# UNITED STATES PATENT AND TRADEMARK OFFICE

### Office Action Summary

10/581,325

HAGIST ET AL.

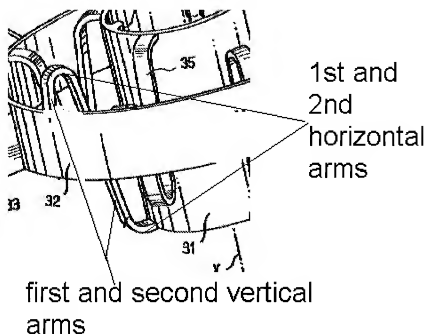
4. Claims 21 and 22 are rejected under 35 U.S.C. 102(b) as being anticipated by Firtion et al (WO 02/40302 .Please note that US patent 7252075 which is a functional equivalent has been used).

Firtion et al disclose a device for retaining a fuel pump in a fuel container of a motor vehicle (see figure 2 and 3) , comprising a **pump holder (30) including: first retaining means (42,43,44)** for supporting the pump holder on a baffle pot; **second retaining means (57 integral with 31)** for supporting the **fuel pump (15)** , and a **damping device (32,34,35 )** connecting the first and second retaining means, the **damping device (34,35 )** comprising a **first annular element (32)** and a plurality of arms (all the vertical and horizontal arms of elements 34 and 35) , wherein the arms are subjected to a torsional or a bending load (inherently) when the fuel pump in the **second retaining means (57 integral with 31)** moves relative to the **first retaining means (42,43,44)**, thereby effecting an elastic retention of the fuel pump, wherein the arms include; at least one first vertical arm (**34 ,35 both have vertical arm**) connected to the **first annular element (32)** ,the at least one first vertical arm extending substantially in a vertical direction and further connected to the **first retaining means (42,43,44 as unit is connected to annular element 32 which in turn is connected to the vertical arm of 34 and 35)**;first and second horizontal arms (**both 34 and 35 have horizontal arms**) spaced apart in the vertical direction (**clearly shown in figure 3A**) ,each of the first and second horizontal arms comprising annular elements (the horizontal arms are interconnected in annular fashion via ring 32), only the first horizontal arm of the first and second horizontal arms being connected to the at least one first vertical arm ,the second horizontal arm of the first and second horizontal arms being connected to the second

retaining means ;and a second vertical arm connecting the first and second horizontal arms (see annotated drawing below) .

Firtion et al disclose a device for retaining a fuel pump in a fuel container of a motor vehicle (see figure 2 and 3), wherein the **second retaining means (57 integral with 31)** includes a section of pipe for receiving the fuel pump, the first and second horizontal arms surrounding a circumferential surface of the section of pipe.
